Bounding Bend, Preliminary Plan No. 120130030

Completed: 11/1/13

Staff recommends Approval of Preliminary Plan 120130030, with conditions:

Figure 2. Preliminary Plan

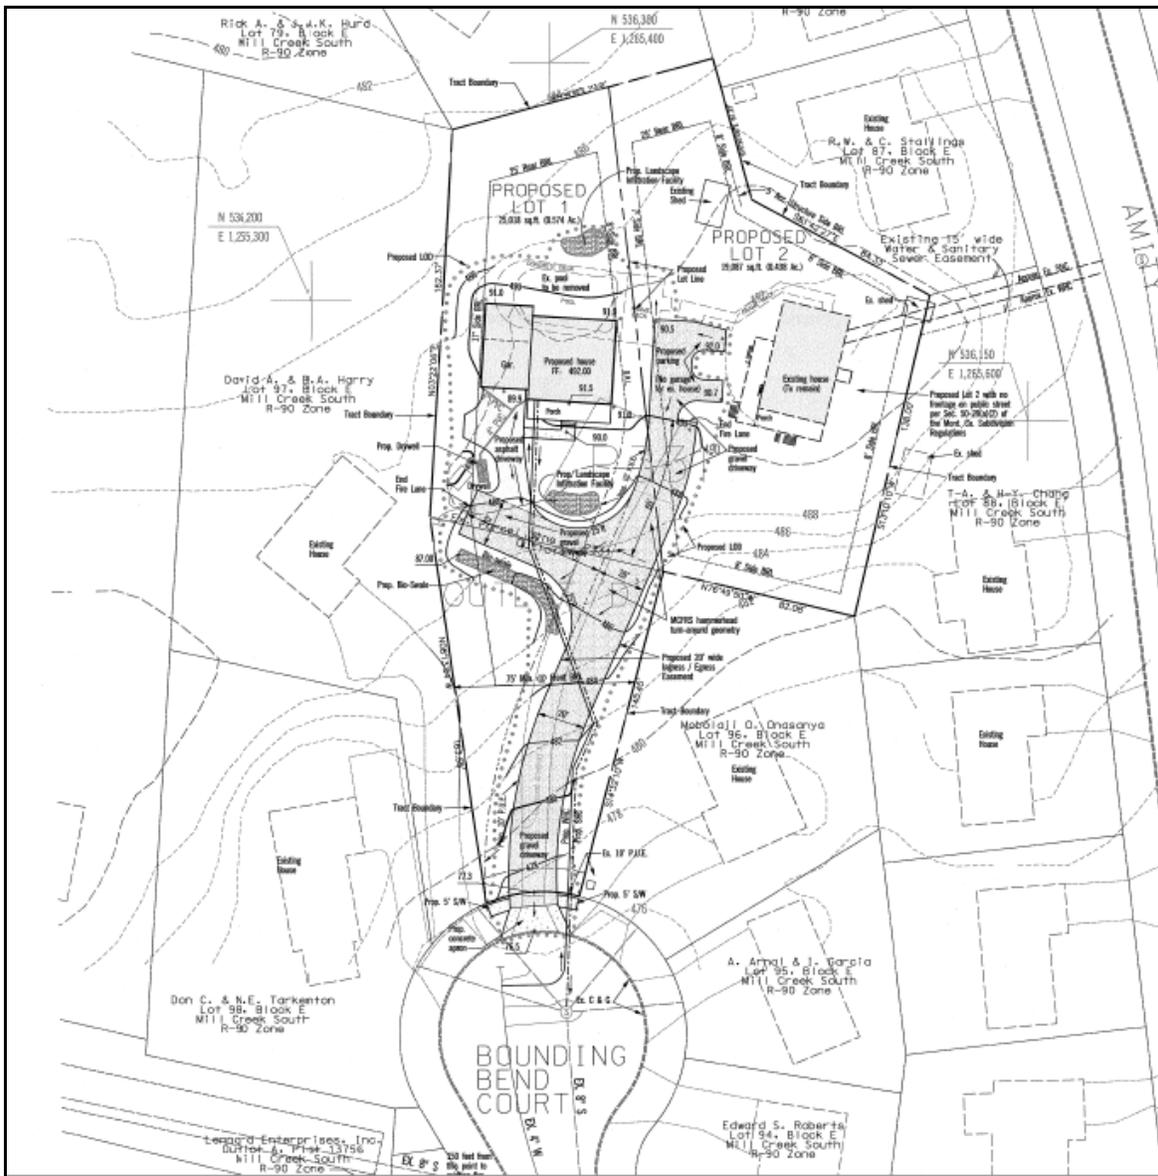
The Applicant proposes to resubdivide the existing lot (Outlot D) and Parcel 331 into two lots for one new one-family detached dwelling with one existing dwelling to remain. Lot 1 is proposed to be 25,018 square feet, and Lot 2 is proposed to be 19,087 square feet. The existing dwelling will remain on the proposed Lot 2. Vehicular access to the lots will be provided by a shared driveway from Bounding Bend Court. The existing house on the proposed Lot 2 will have no street frontage and will access the street using the driveway of the other proposed lot (Lot 1). An ingress/egress easement will be established on the record plat to guarantee continued access and, if necessary, future connection of utilities for the proposed Lot 2 across proposed Lot 1.

Figure 4. Specimen trees with critical root zones circled in blue that are located within the northern portion of the subject site.

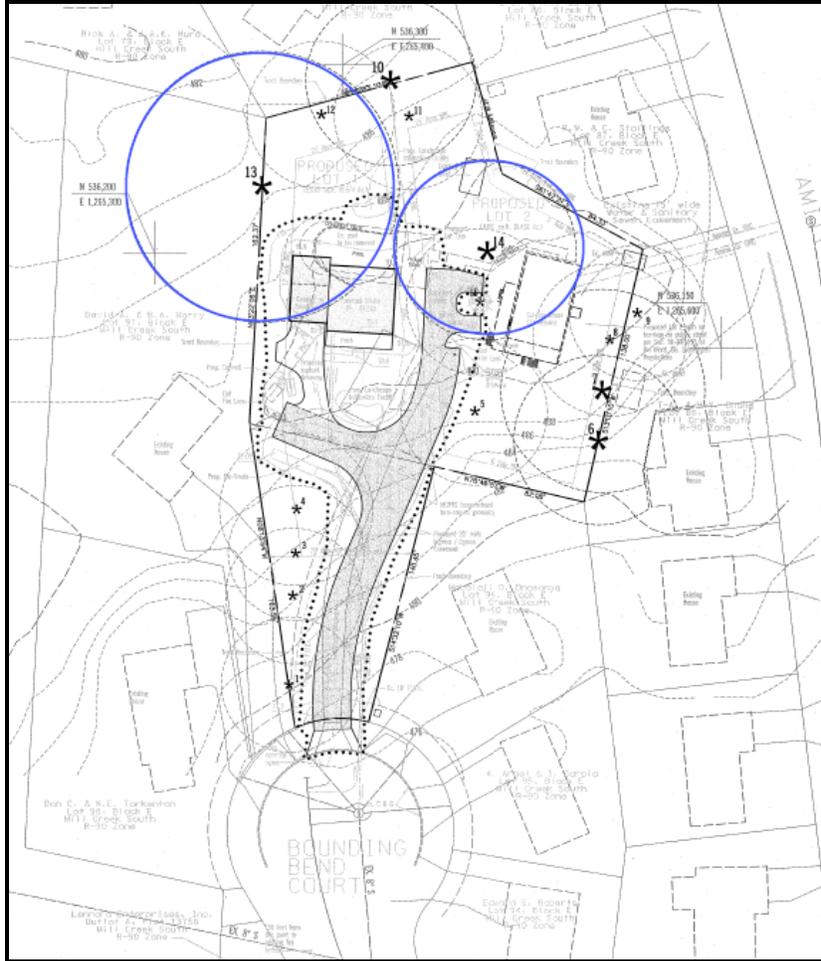
3. The impacts to tree #13 may not exceed 12% of the critical root zone as shown on the Preliminary Forest Conservation Plan. This includes any house location.

4. The impacts to tree #14 may not exceed 14% of the critical root zone as shown on the Preliminary Forest Conservation Plan. This includes any house location.

The Applicant submitted a variance request on November 5, 2012, for the impacts to specimen trees as depicted in Figure 4 and on the attached PFCP (Attachment 4). The Applicant is requesting a variance to impact the critical root zones (CRZ) of two specimen trees greater than 30" diameter at breast height (DBH) that are considered high priority for retention under Section 22A-12(b) (3) of the County Forest Conservation Law. These two trees include a 48" DBH red maple (tree #13) and a 32" DBH silver maple (tree #14).

Mitigation for Trees Subject to the Variance Provisions – Because the Applicant proposes to disturb less than 30% of the CRZs of each of the two specimen trees and to provide tree protection measures, Staff is recommending no additional mitigation for this variance request.

Staff recommends that the variance be granted.
